ADDENDUM NUMBER TWO

**CHHS SCIENCE LAB RENOVATION
HAYWOOD COUNTY SCHOOLS**

MLA PROJECT NUMBER: 19017

DATE OF ISSUE: January 24, 2020

1 POWER PLAN
E3 SCALE: 1/4" = 1'-0"

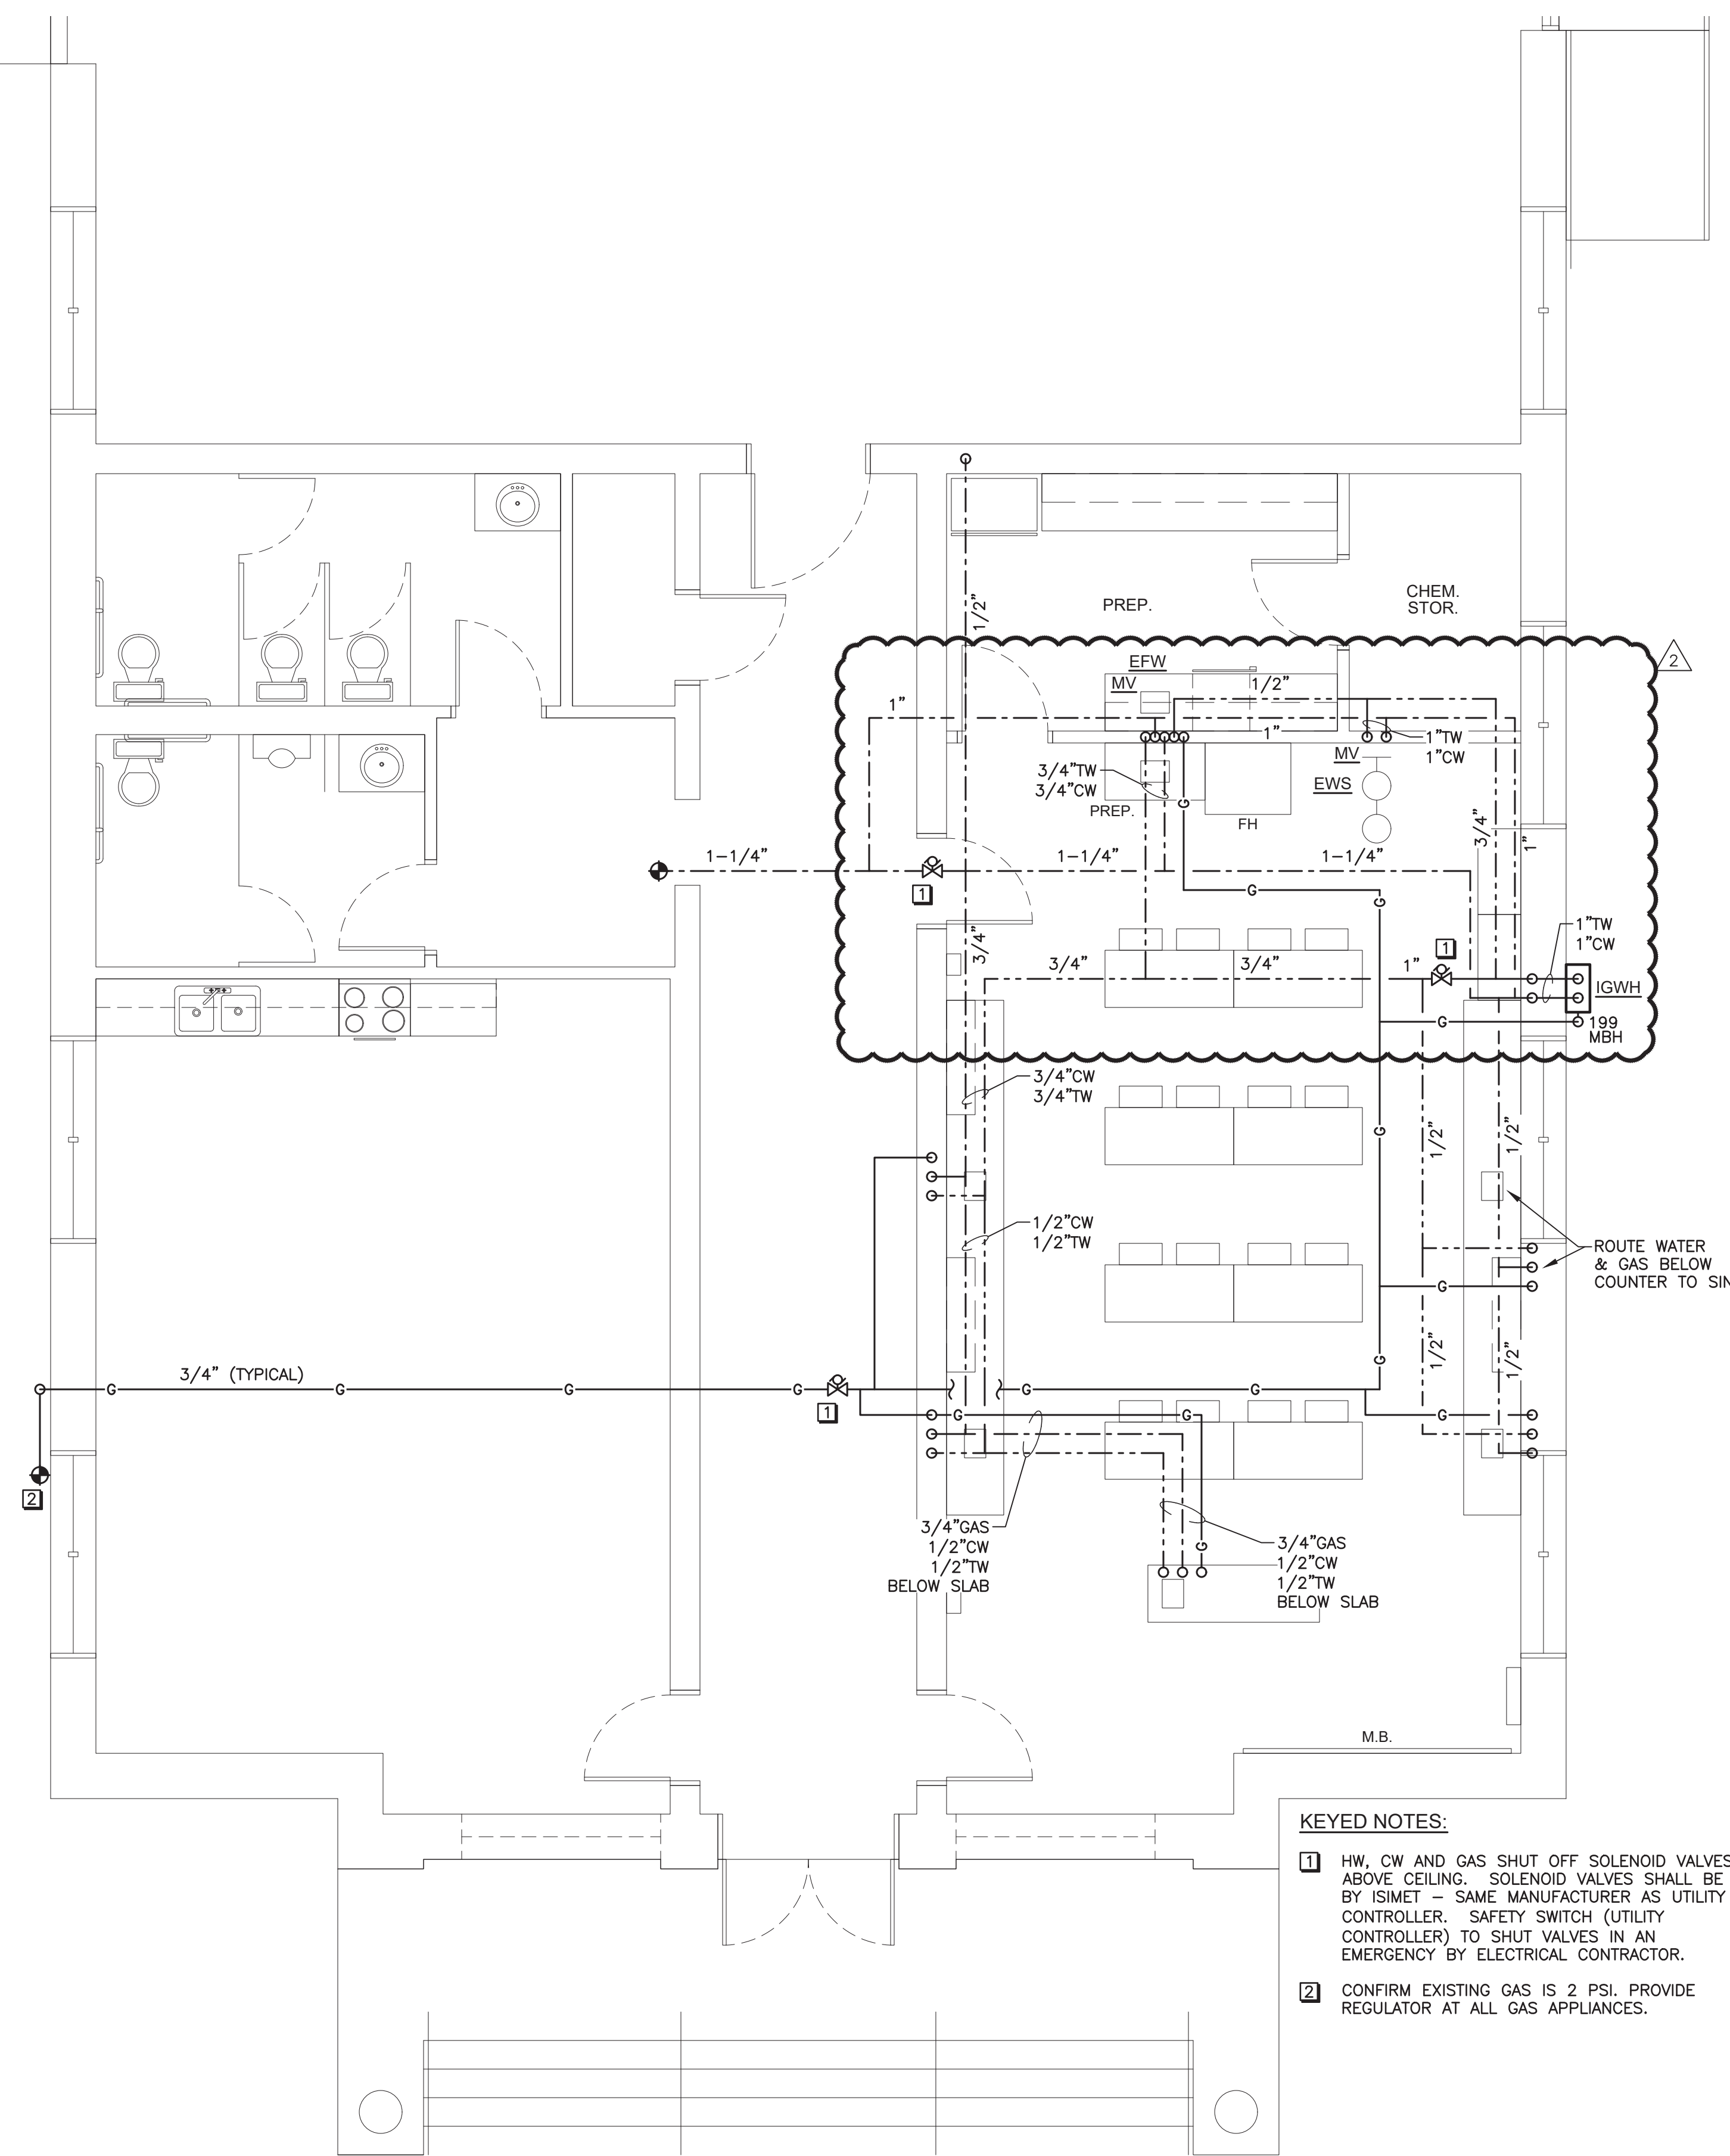
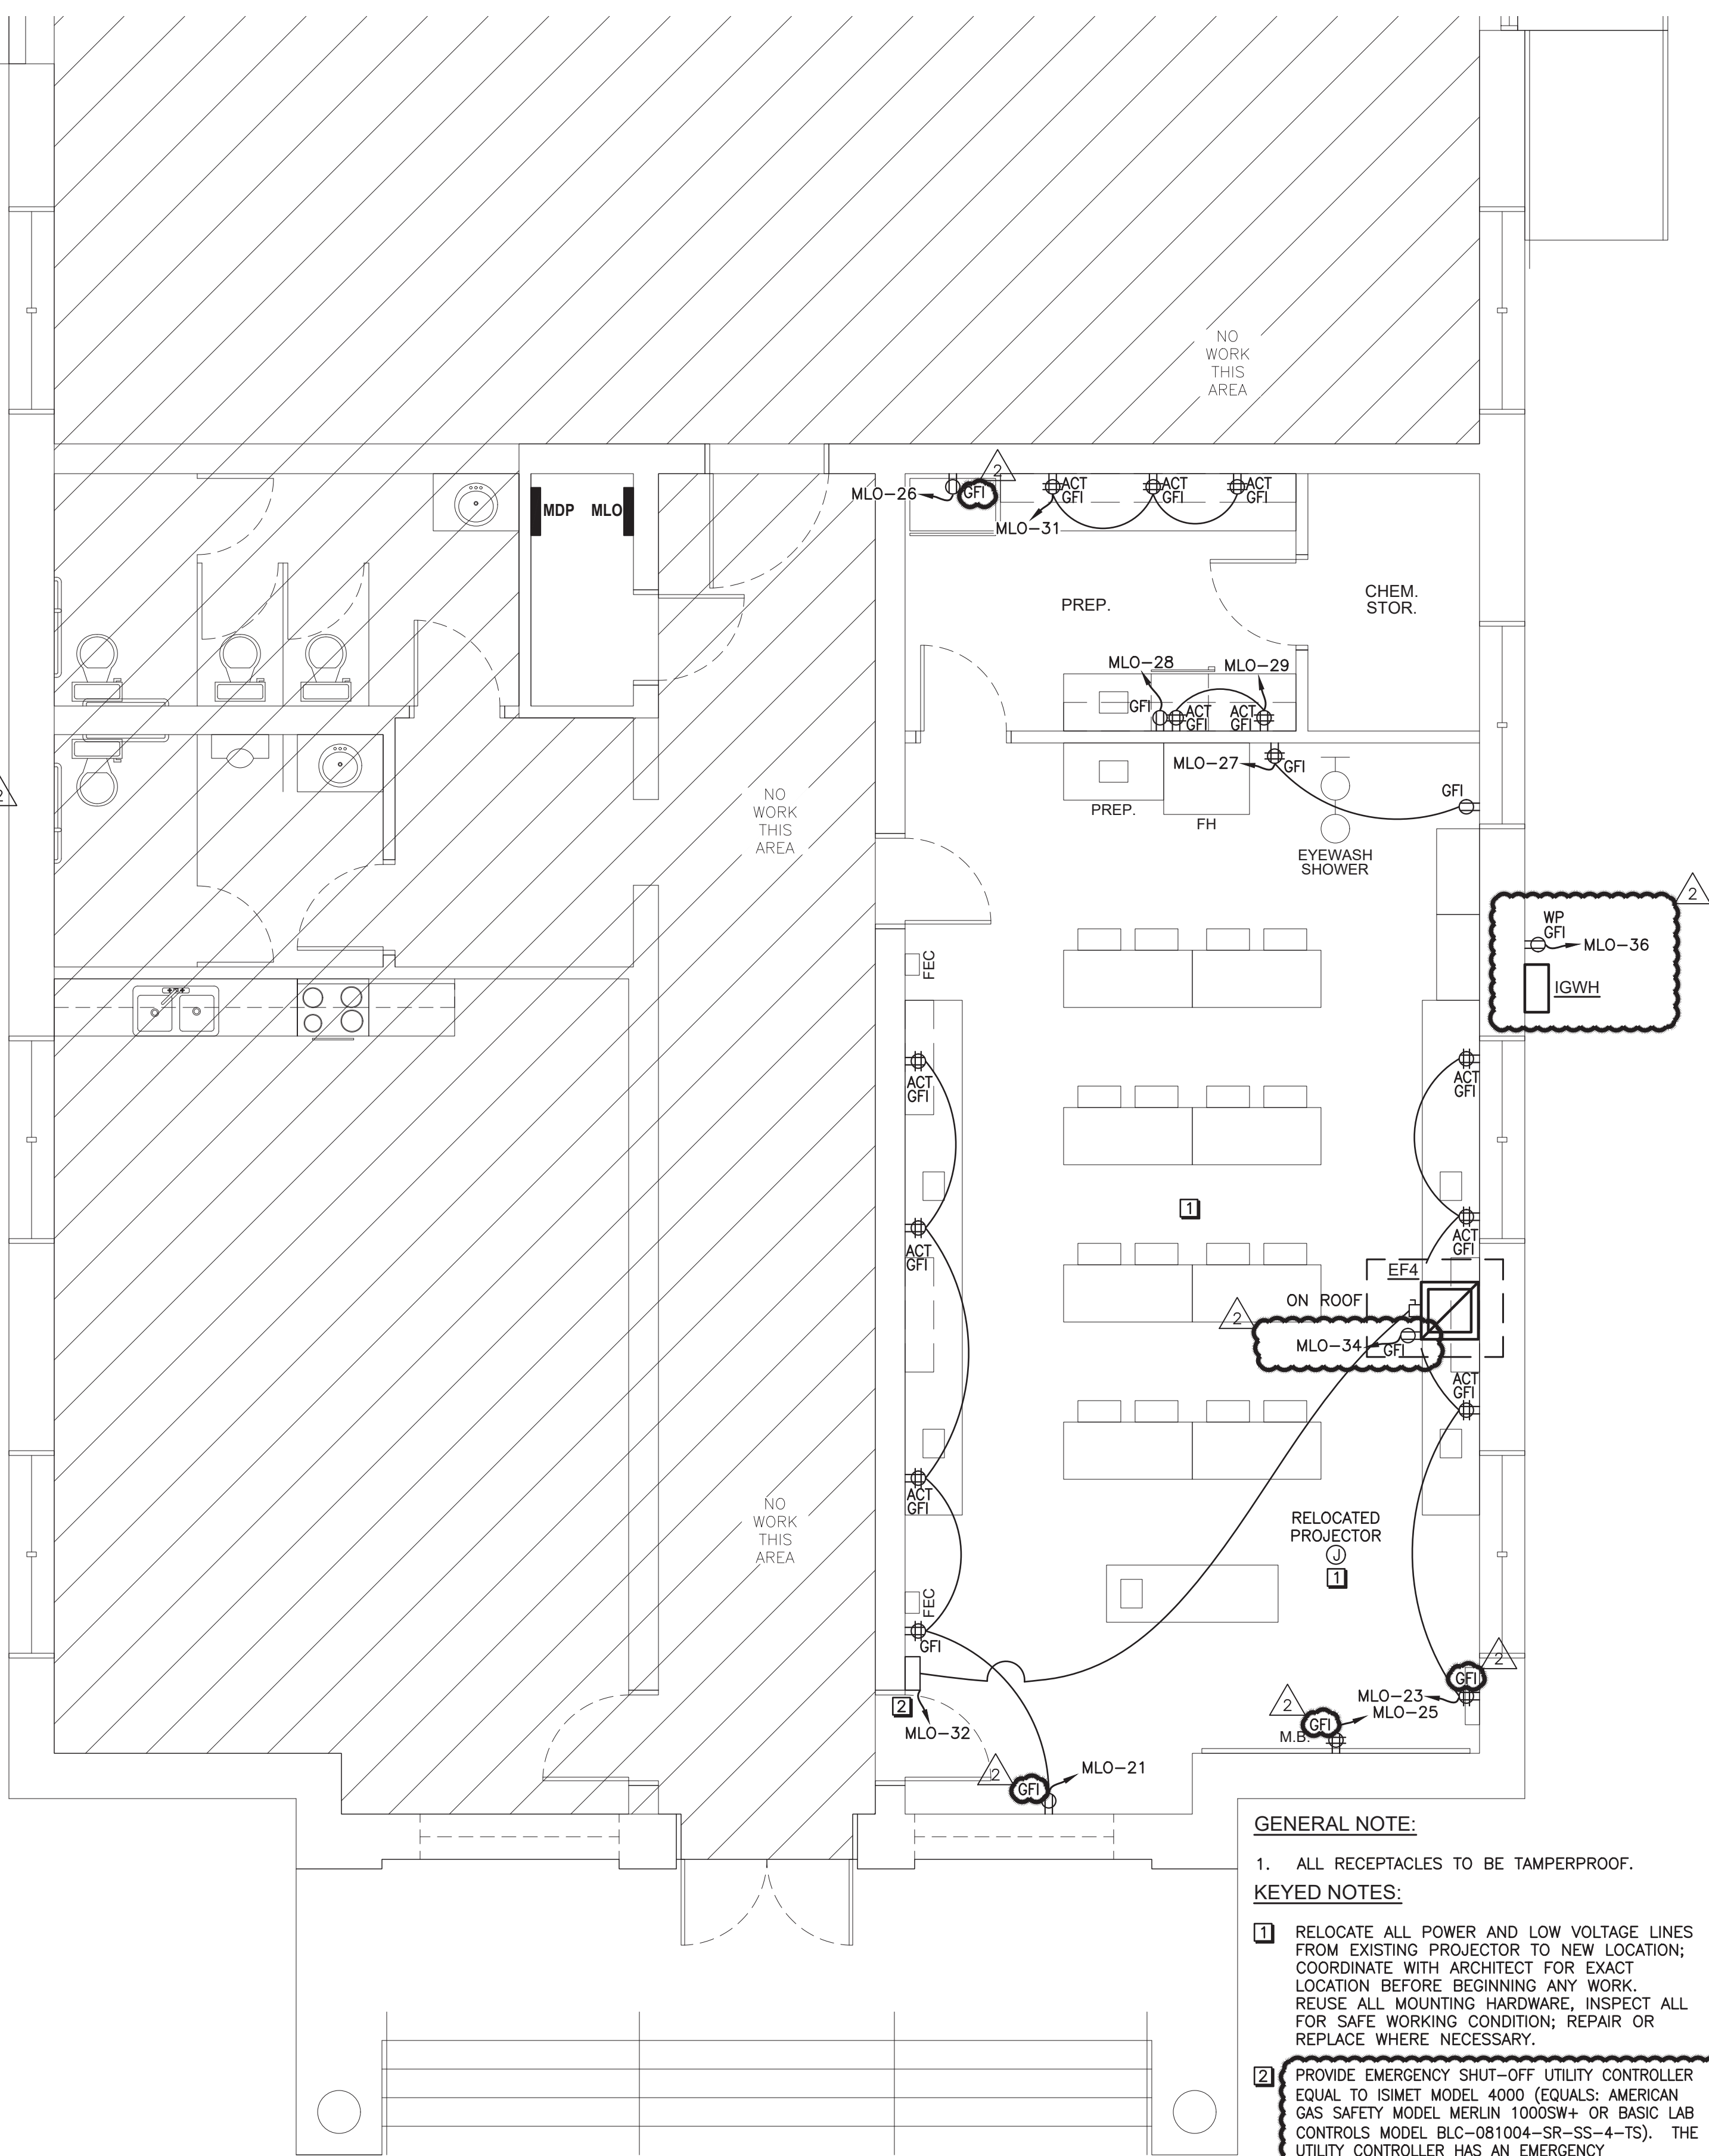
1. See E1, E2, E3, P3 for :
 - a. Sheets E1 and E3. The legend and fixture schedule were revised
 - b. Sheet E3. A weatherproof GFCI receptacle was added for the water heater Emergency Shut Off switch
 - c. Sheet E3. A GFCI receptacle was provided for maintenance at exhaust fan in the attic
 - d. Sheet E3. All GFCI receptacles were labeled
 - e. Sheet P3. Water supply lines added.
2. See A201 for revision to casework and Alternate
